# ALTERATIONS & ADDITIONS

## 49 NORFOLK AVE,COLLAROY

## SCHEDULE OF CHANGES

DRAWING TITLE	LOWER GROUND FLOOR PLAN
PROJECT	NEW DWELLING

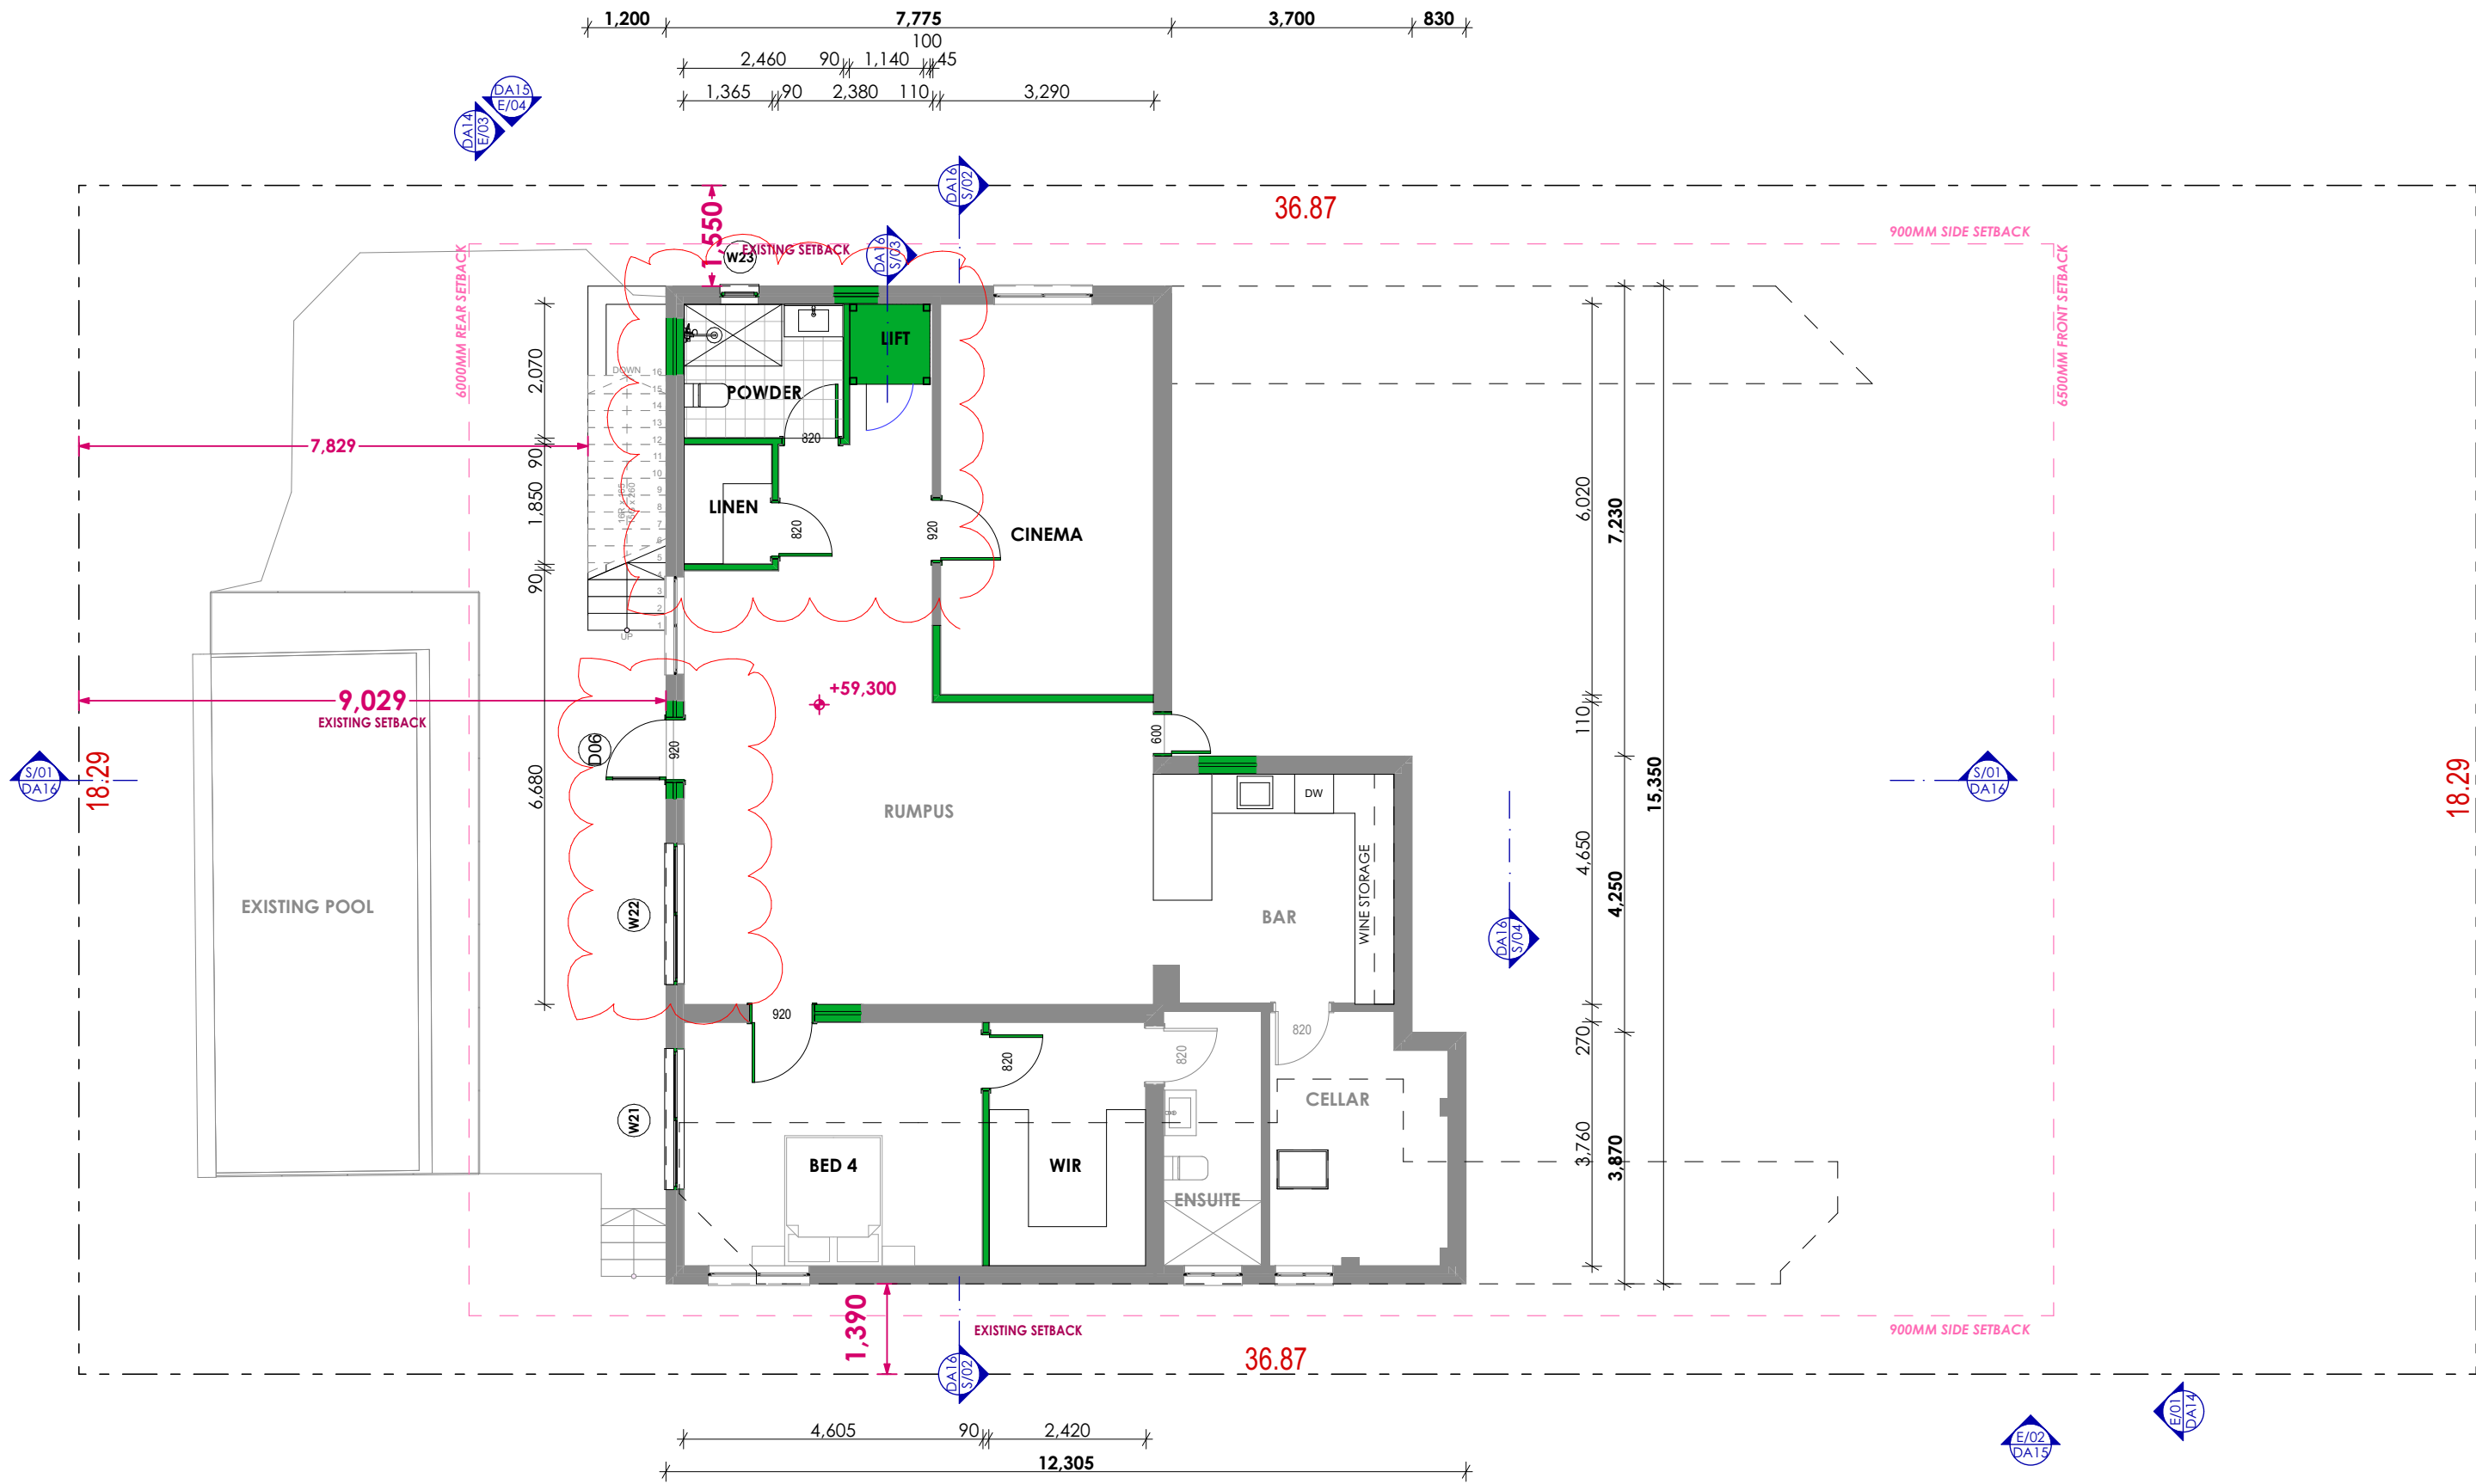
DATE	NO	CHANGES
11/04/2025	1	Architectural Plans: Redesigned lower ground floor plan layout at the Southwestern corner. Locations of powder room, storage and linen adjusted.
	2	Architectural Plans: Replace an existing door on the South side in the lower ground floor with a new window (W22), and replace an existing window with a new door (D06).
	3	Architectural Plans: Add a new lift for ground floor and first floor near staircase
16/04/2025	4	Architectural Plans: Redesigned lower ground floor plan layout at the Southwestern corner. Storage room was changed into linen room; linen area from the previous revision was changed into lift which serves lower ground level and ground level.
	5	Architectural Plans / Window Schedule: joined W13 and W14, shown as W13 on Window Schedule. Detailed floor plan added to illustrate the dimensions of W13.
